NH000-0006-02(055) Dougherty

P.I. No.: 422550

SR 91 & SR 520/US 82 Interchange

SUBJECT: IMPLEMENTATION OF VALUE ENGINEERING STUDY ALTERNATIVES

S-5

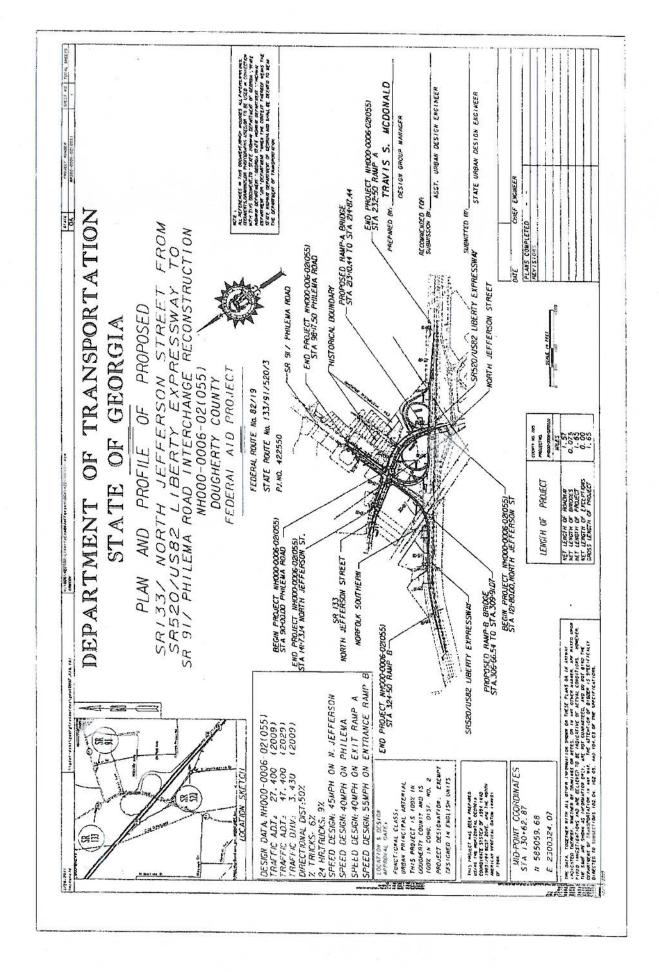
<u>VE Alternative S-5</u> – "Reduce the length of the Ramp A Bridge by 37 ft. by providing a retaining wall abutment on the west end"

Recommendation: **Do Not Implement**. A revised estimate indicates that this alternative would have a cost increase of \$240. In addition, there are more maintenance issues with MSE walls and the approach roadway than there are with typical spill through abutments. MSE wall abutments limit the possibility of future expansion for both the road being carried as well as the facility beneath the structure. Due to sequence of construction, coordination with subcontractors and equipment, bridge costs and wall costs are higher than the general bridge and wall costs for separate structures.
